PRODUCT CHANGE NOTIFICATION

#PCN-TT-O4BB-14

Business Unit	Product Line Code	Type of Change	Action	Date of issue
TT	CL1	Electrical	Notify Distributors and Field	5/28/2014

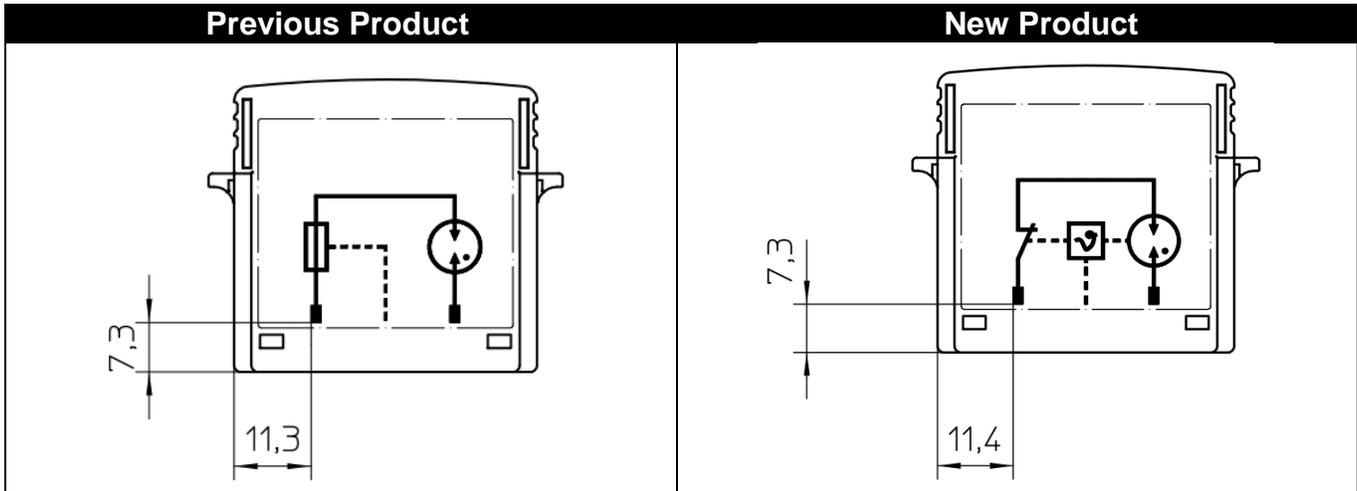
The internal construction of multiple SPD plugs has been revised. The behavior of disconnection was changed from dynamic to thermal. Technical values remain unchanged. The printing on the plugs will be changed as indicated. Approvals remain unchanged and will be printed according to the product.
